Technical Service BULLETIN

TIRE PRESSURE WARNING SYSTEM LIGHT ON

'04 – '05 Highlander

REVISED
BR006-05
BRAKES

Parts Identification

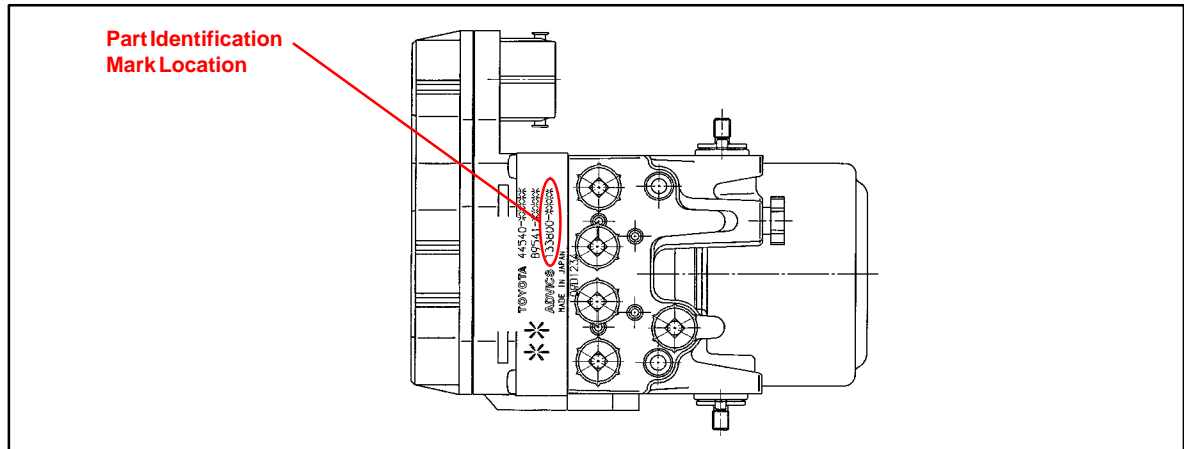
To identify the correct actuator service part, refer to the new part identification mark number in the table below. To locate the part identification number on the part, refer to the illustration below.

MODEL	PART NUMBER	OLD PART IDENTIFICATION	NEW PART IDENTIFICATION	PART NAME
Highlander (2WD)	44050-48110	133800-7371 133800-7370	133800-7372	Actuator Assembly, Brake
Highlander (4WD)	44050-48120	133800-7381 133800-7380	133800-7382
